Rezoning Application: PD 26-0555 Rev

APPLICATION NUMBER: PD 26-0555

Case Reviewer: Tim Lampkin, AICP

CROSSINGS CHURCH MIXED USE PLANNED DEVELOPMENT GENERAL SITE PLAN

8.0 PROPOSED SITE PLAN (FULL) Page 1

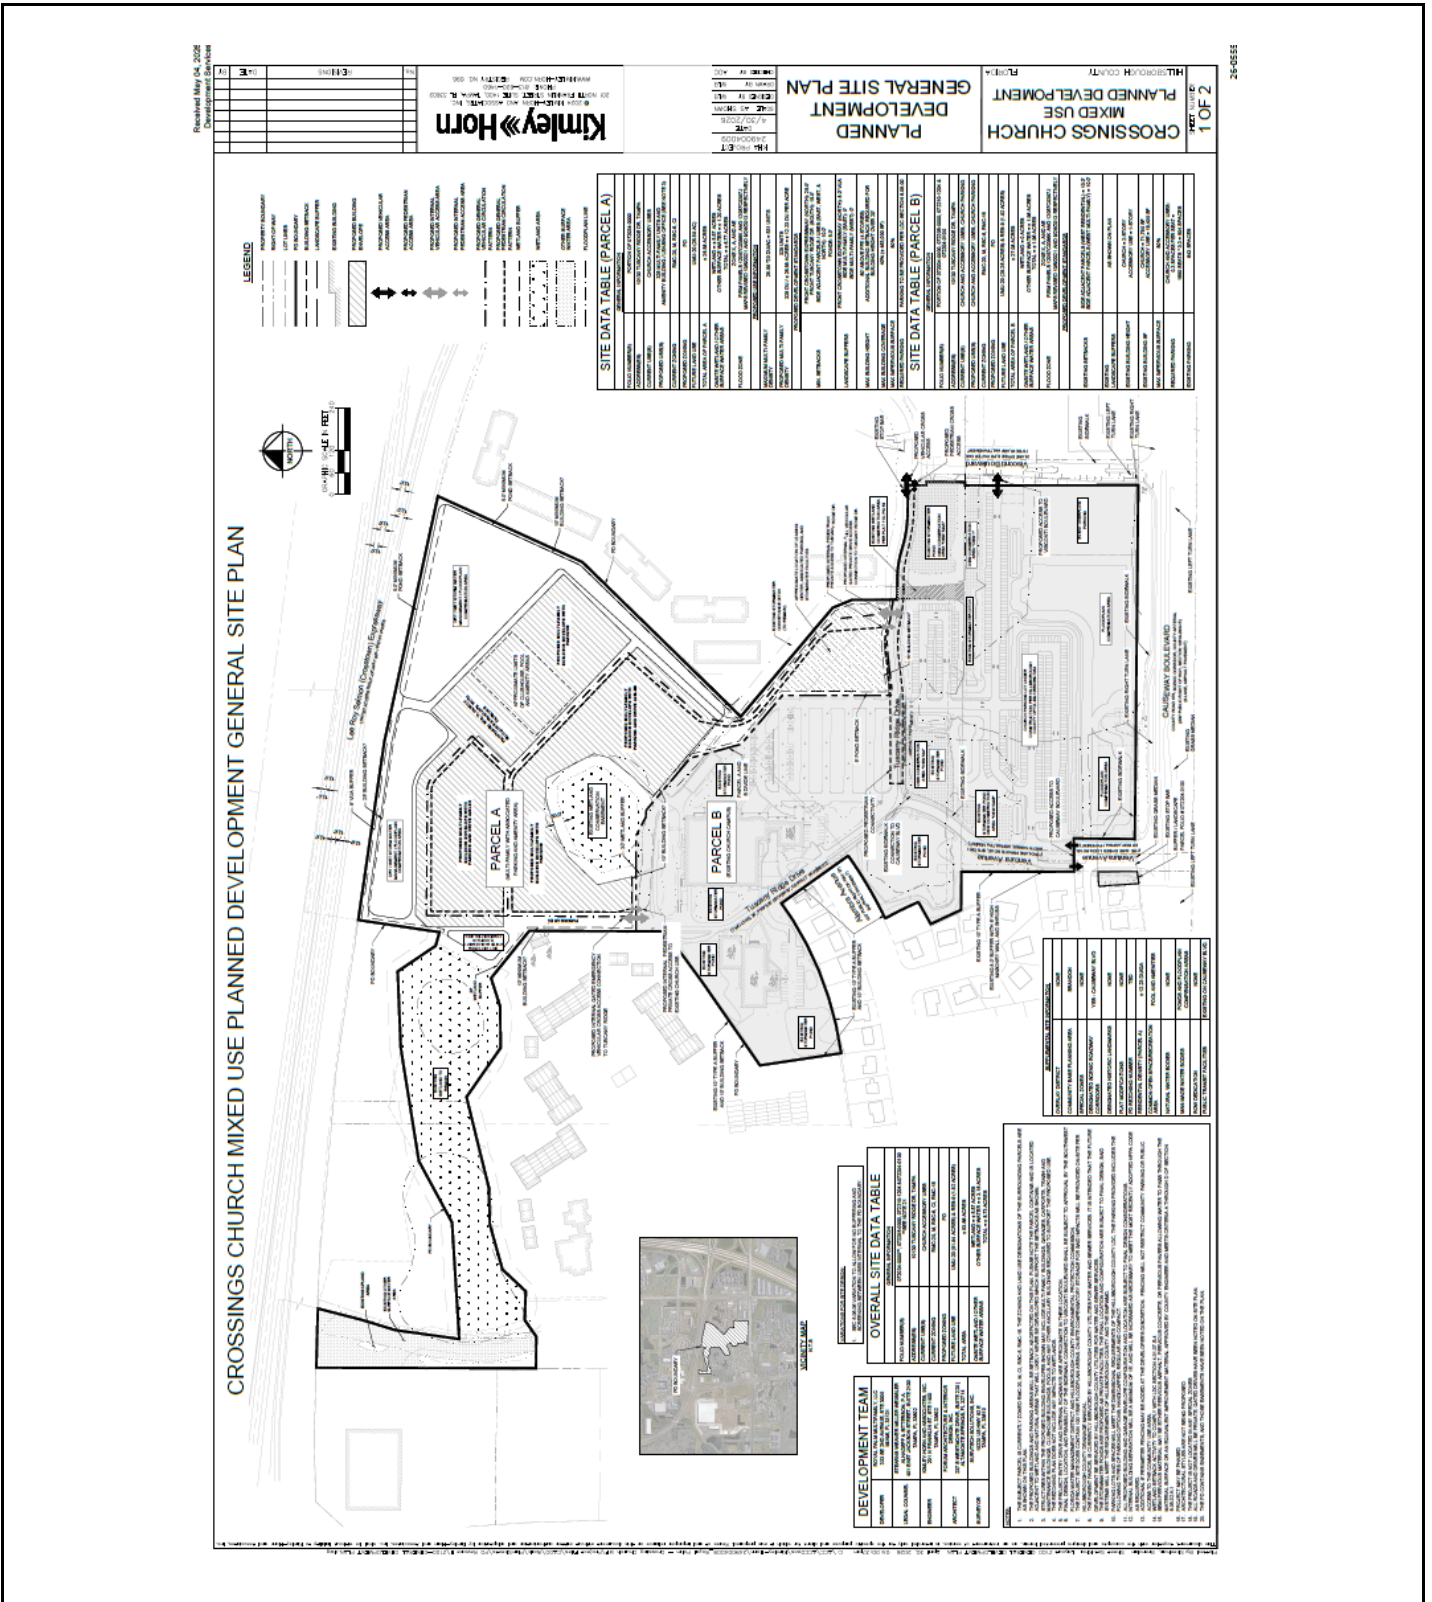
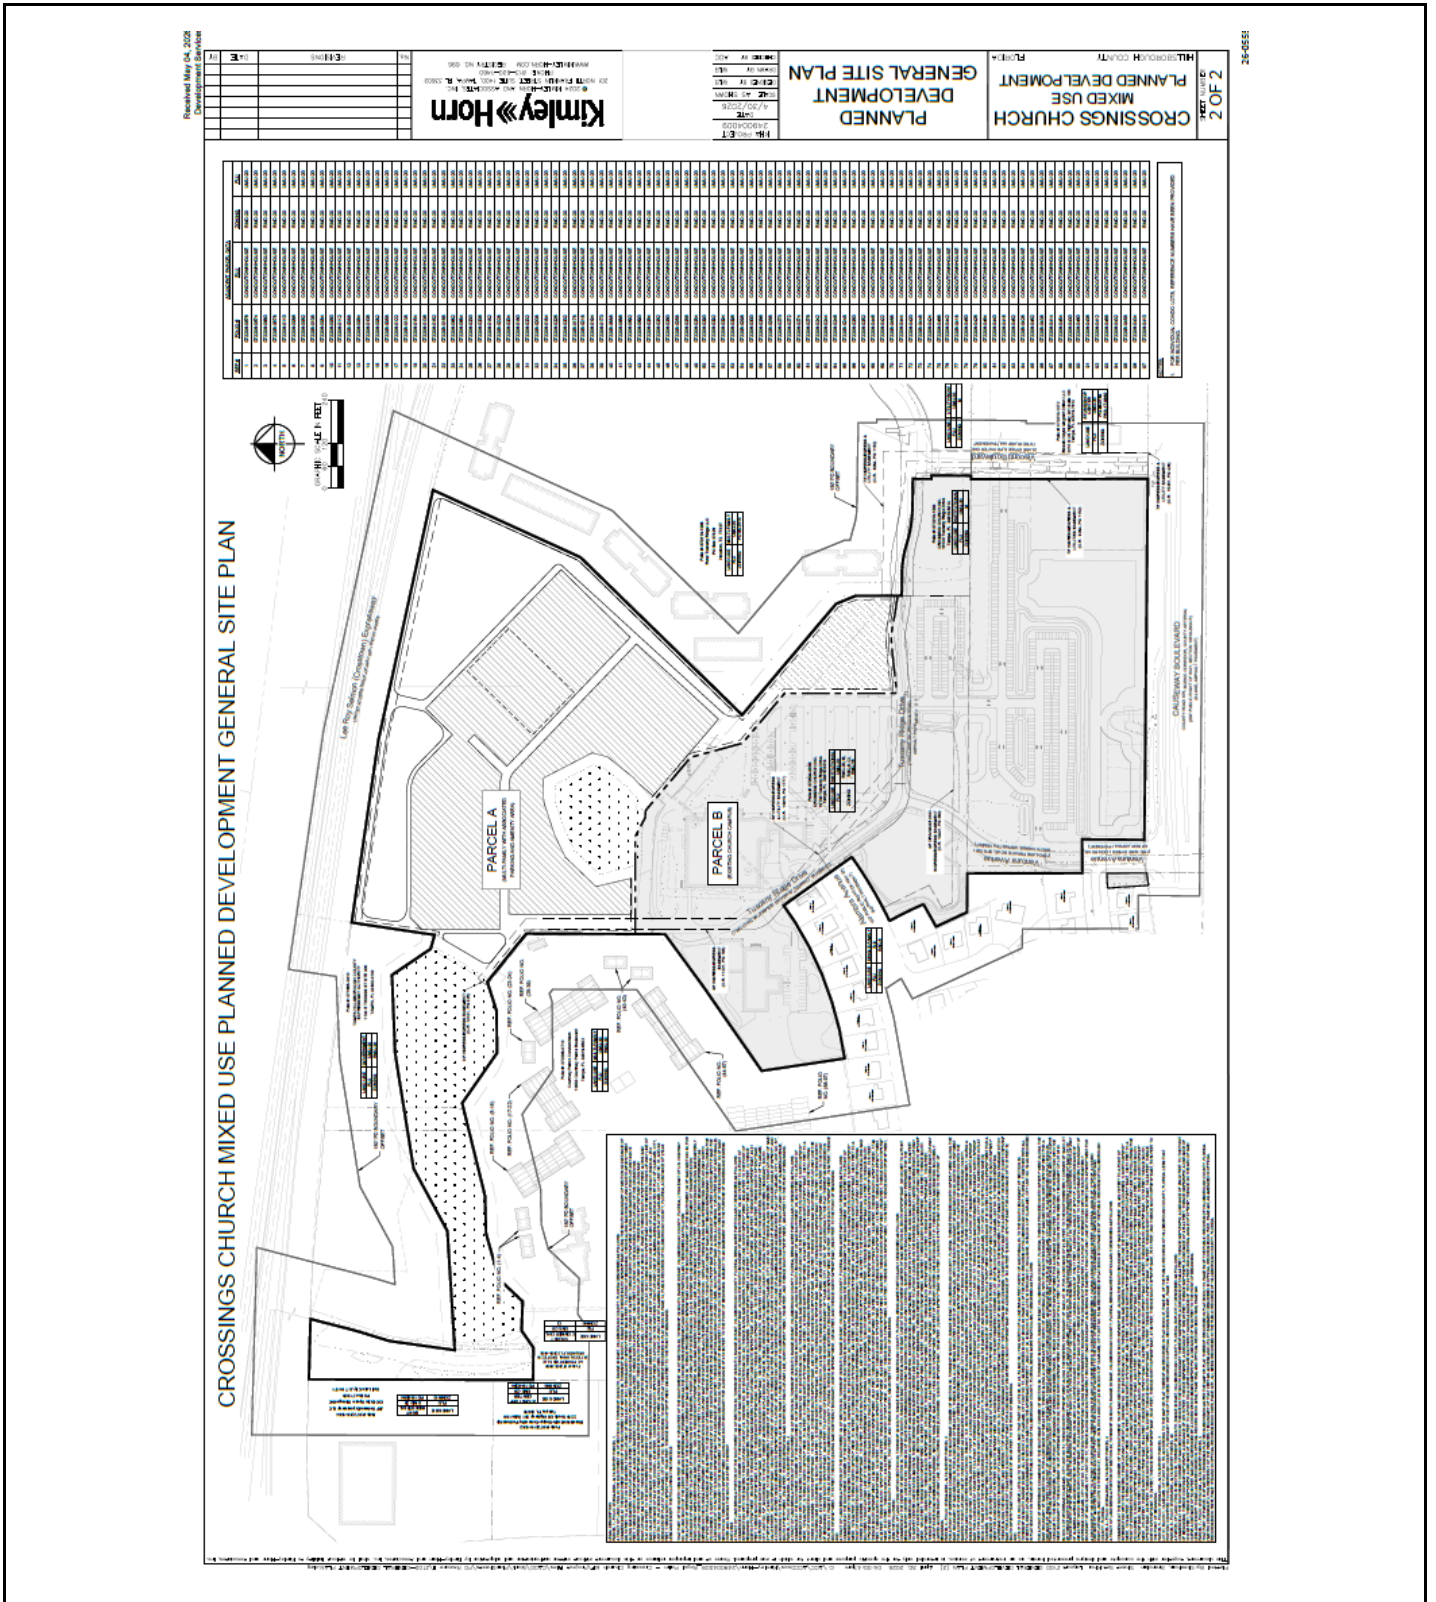
1. Revise "Front Crosstown Expressway" to "Rear Crosstown Expressway"
2. Prior to Certification, the applicant shall revise the PD plan sheet note #6 to state "Final design and location of the sidewalk connection to Visconti Boulevard shall be determined at the time of site development review."
3. Revise "15' Building Setback" to "10' Building Setback" off Tuscany Ridge Road.

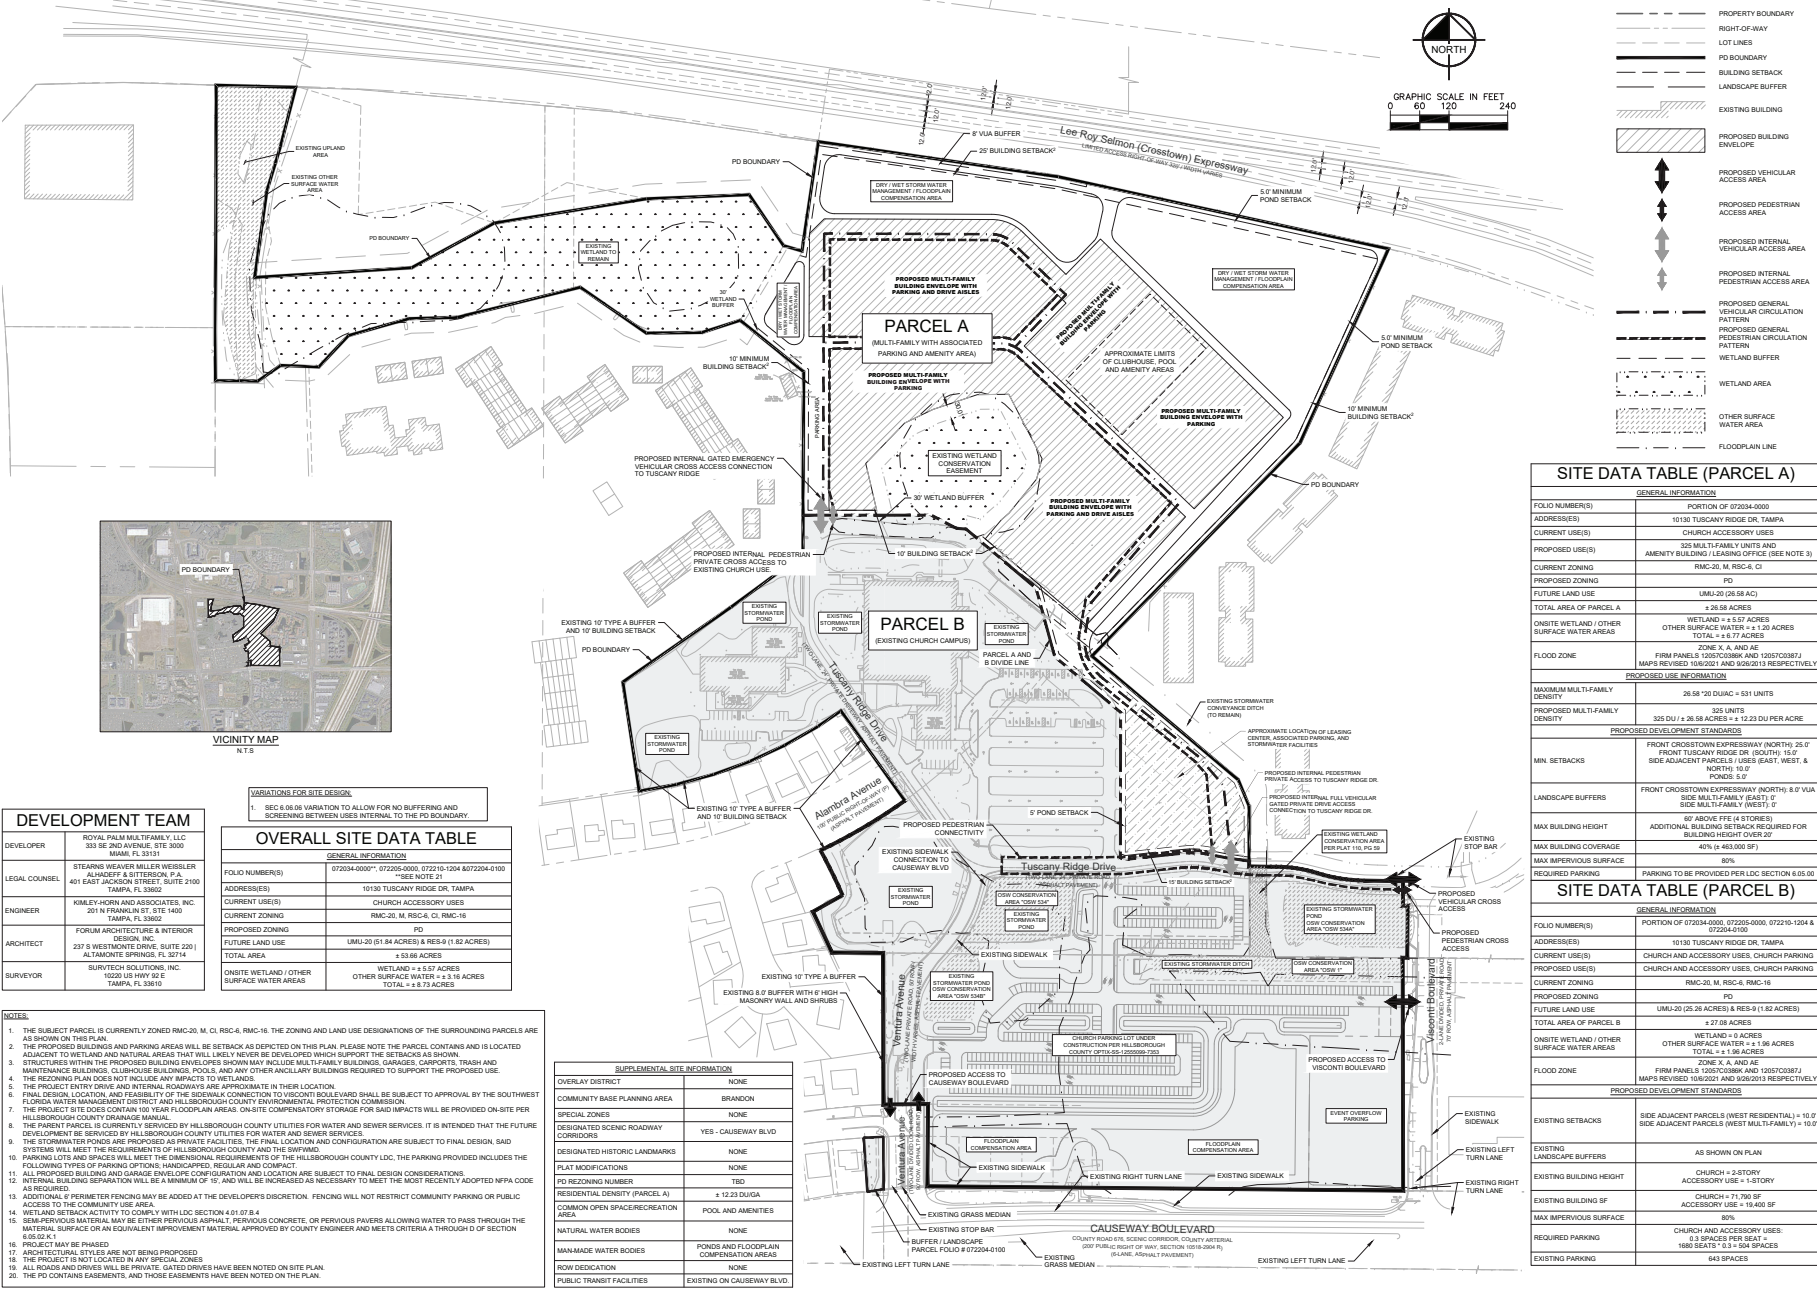
- Prior to Certification, the applicant shall revise the PD plan sheet note #6 to state “Final design and location of the sidewalk connection to Visconti Boulevard shall be determined at the time of site development review.”

- THE REZONING PLAN DOES NOT INCLUDE ANY IMPACTS TO WETLANDS.
 - THE PROJECT ENTRY DRIVE AND INTERNAL ROADWAYS ARE APPROXIMATE IN THEIR LOCATION.
 - FINAL DESIGN, LOCATION, AND FEASIBILITY OF THE SIDEWALK CONNECTION TO VISCOUNTI BOULEVARD SHALL BE SUBJECT TO APPROVAL BY THE SOUTHWEST FLORIDA WATER MANAGEMENT DISTRICT AND HILLSBOROUGH COUNTY ENVIRONMENTAL PROTECTION COMMISSION.
